• **ENGINE—4.2L—MEXICO VEHICLES ONLY—VIBRATION IN GEAR WITH A/C ENGAGED—VEHICLES EQUIPPED WITH AUTOMATIC TRANSMISSION ONLY** • **VIBRATION—MEXICO VEHICLES ONLY—VIBRATION IN GEAR WITH A/C ENGAGED—VEHICLES EQUIPPED WITH 4.2L ENGINE AND AUTOMATIC TRANSMISSION ONLY**	**Article No. 02-7-1**

FORD: 2000-2001 F-150

Figure 1 - Article 02-7-1

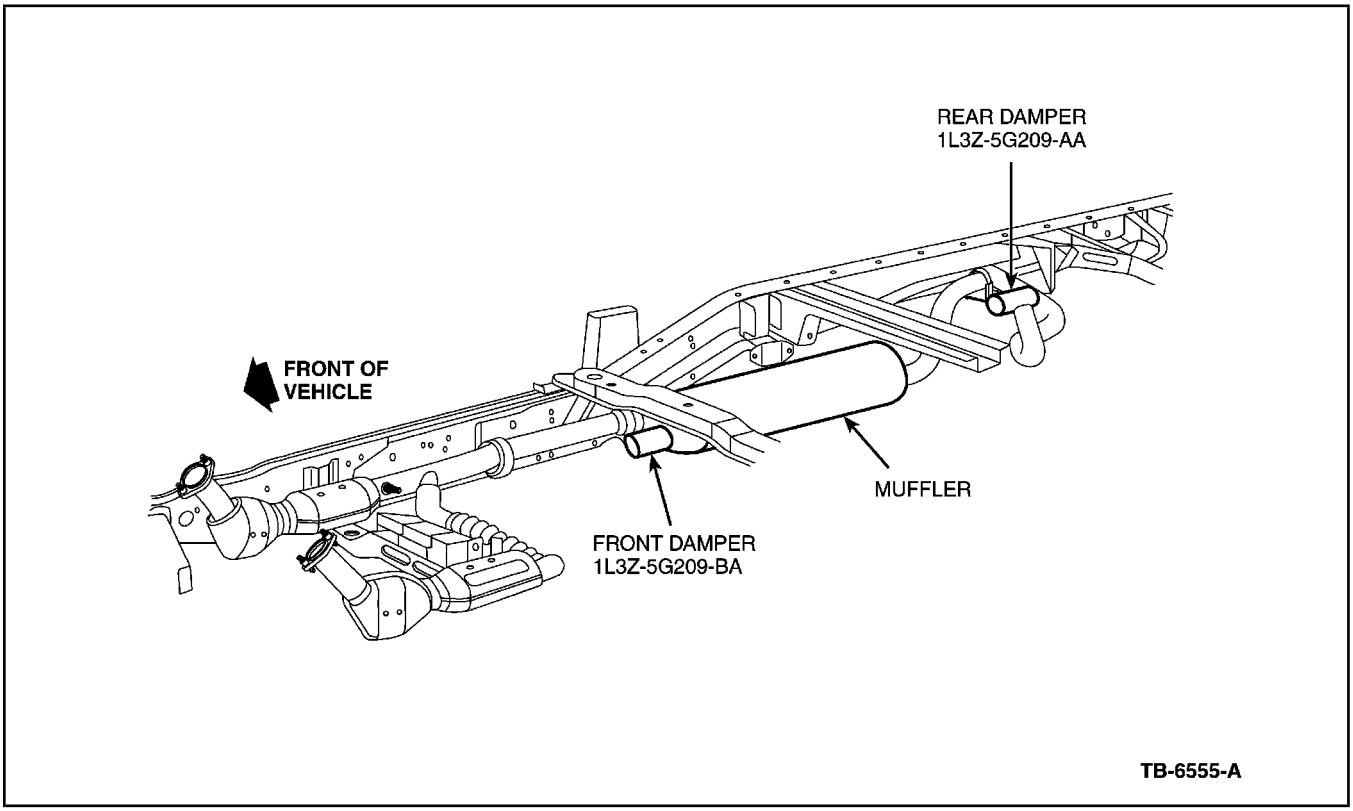
1. Perform the diagnostic self-test to check for Diagnostic Trouble Codes (DTCs). Resolve all codes that are present using the appropriate Powertrain Control/Emissions Diagnosis (PC/ED) Service Manual before proceeding.
2. Verify if contact exist between exhaust system and chassis.
3. Verify the correct engine mounts application as follows:
   - A/T engineering numbers YL34-6038-CA (R.H.) & YL34-6B032-AA (L.H.)
   - M/T engineering numbers YL34-6038-DA (R.H.) & YL34-6B032-DA (L.H.)
4. Make sure that the flywheel and torque converter alignment marks are aligned.
5. Install the Exhaust System Damper 1L3Z-5G209-BA as shown (Figure 1).

IF THE VIBRATION IS STILL PRESENT AFTER THE FRONT DAMPER INSTALLATION, IT WILL BE NECESSARY TO INSTALL A SECOND DAMPER P/N 1L3Z-5G209-AA AT THE REAR OF THE MUFFLER.
